AMBLER BOROUGH PLANNING COMMISSION

1. Review “220 S. Chestnut Street Sketch Plan” proposing to demolition an existing warehouse / industrial building to construct 16 stacked townhomes. Parking is provided in the rear of the buildings with access to Maple Avenue.

Reference: Sketch Plan Application
220 South Chestnut Street
B/U 01-028/025, Parcel 01-00-01157-01-2

SUBJECT: Sketch Plan Review – 220 S. Chestnut Street (MCPC #25-0054-001)

MULTI-FAMILY SKETCH PLAN
PREPARED FOR
S. CHESTNUT STREET

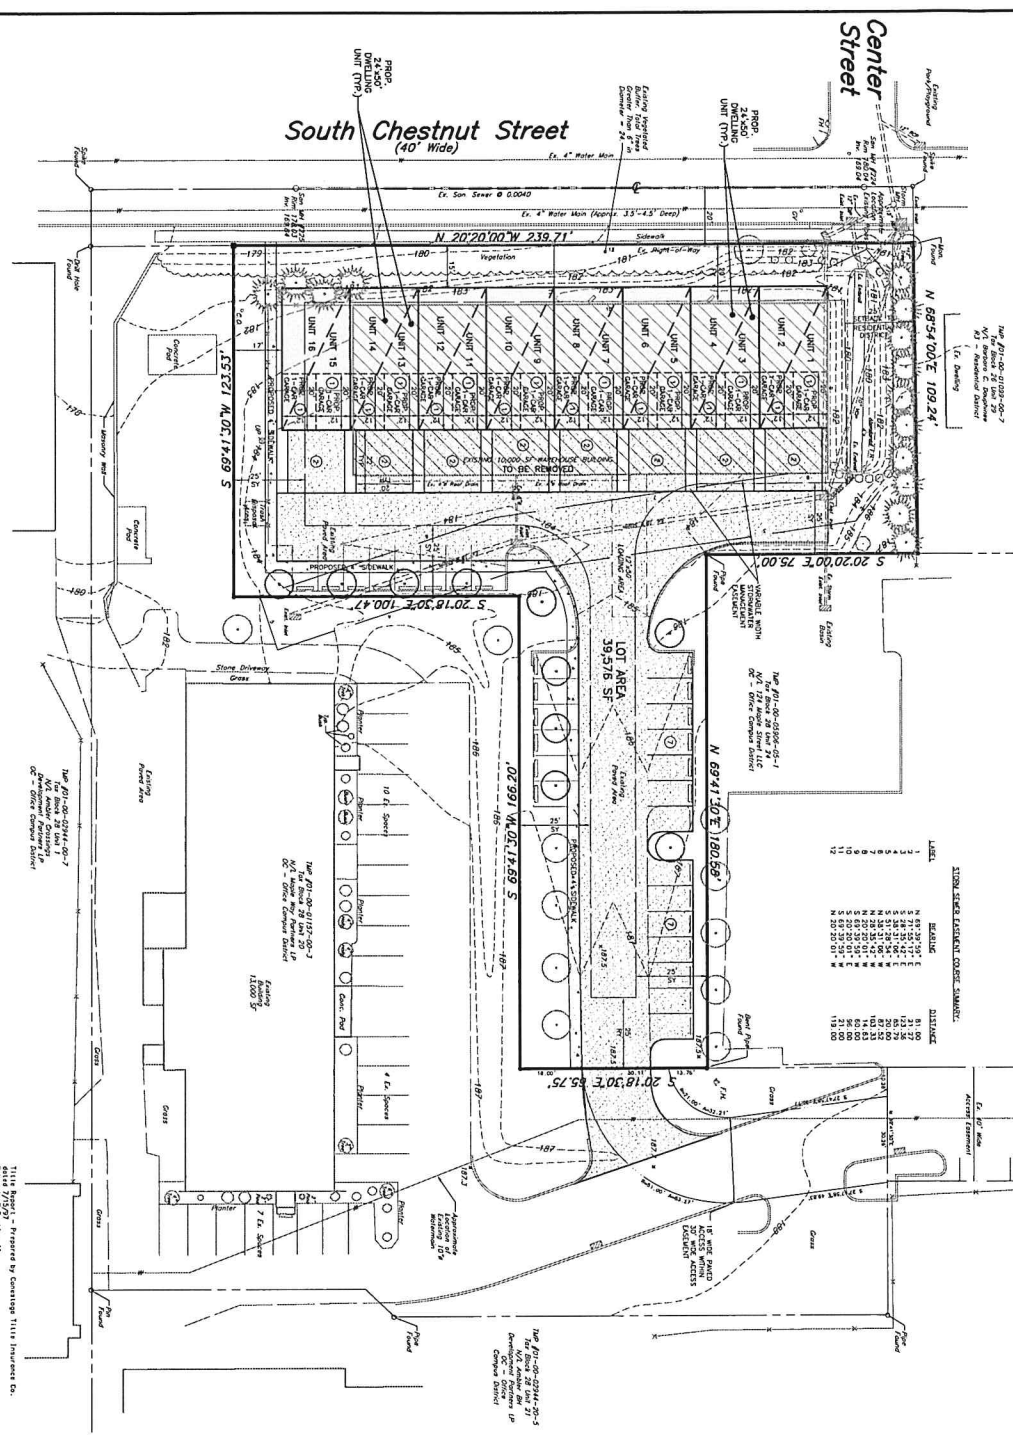
- a. §27-202 – The proposed use and configuration may not meet the Borough Zoning Ordinance definition of Single-Family Attached Dwelling. The proposed use may better fit as a Multifamily Dwelling as defined in the Borough Ordinance.

- b. §27-802.1.A & The R-3 District permits single-family detached, twins, duplexes, and single-family attached uses. The Borough should determine if the proposed multi-family use is permitted in the R-3 District.

- c. §27-803 – The minimum lot area for single-family attached dwellings is 2,500 sf. The applicant proposes 16 dwelling units. The lot is 39,576 sf. This equates to 17.6 DU/ac or 2,474 sf/DU.

- d. 27-806 – Shade trees are required along the street frontage. Buffer areas, 10-feet wide, are required where the single-family attached uses abut single-family detached uses or districts and where all residential uses abut nonresidential uses or districts.

- e. 27-807.1 – For all single-family attached units there shall be no more than six dwelling units in a continuous row for each building. The applicant proposes 16 units in a continuous row of 8 buildings.

- f. 27-807.3 & 5 – The R-3 District includes additional setbacks from zoning district boundary lines for buildings and for parking associated with single-family detached dwellings. If the lot is rezoned, these setbacks appear to impact the proposed layout of the lot. The setbacks should be depicted on the plan.

4. If residential uses are permitted on this lot, we recommend that the frontage along South Chestnut be developed to integrate with the existing residential uses in the area. For example, building elements typical of a residential frontage and pedestrian access to the sidewalk along South Chestnut for each unit, street trees, lighting, etc. should be considered. The example building photograph shows this configuration; however, the sketch plan does not.

5. The need for stormwater management was not evaluated. The applicant would be required to address all aspects of the ordinance if new impervious cover exceeds 750 sf or if land disturbance exceeds 5,000 sf. The applicant shall reference Table 26-406.1 (Section §26-406 of the Stormwater Management Ordinance) for applicability.

6. If the buildings will be sprinklered, the applicant should investigate the capacity of existing water utilities near the lot.
 7. The findings of a Title Report dated July 15, 1997, are listed on the plan. Any future land development application may require an updated, more recent Title Report and more information regarding the listed items, easements, etc.

8. The plan is based on a survey completed in 1997. A recent survey will be required with any future land development application.

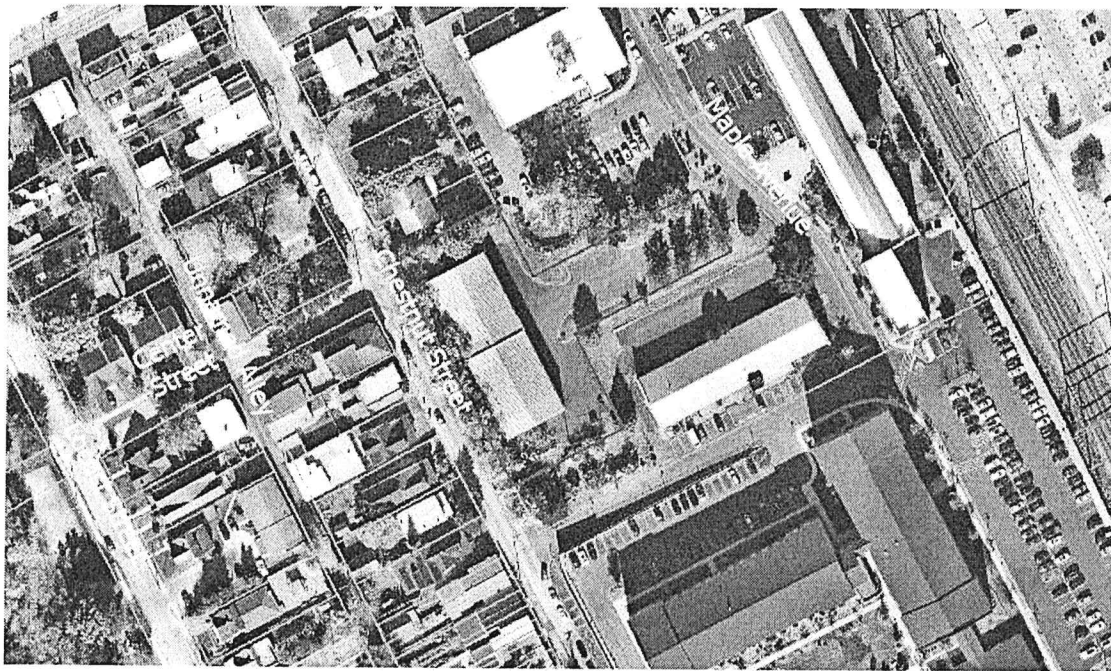
- C. Property Line Buffers. We commend the amount of new plantings proposed; however, we would recommend that additional trees be installed along the southern property line between the proposed sidewalk and the neighboring property. Furthermore, a landscape buffer surrounding the proposed trash disposal area would help to screen it from the proposed residences as well as neighboring properties.
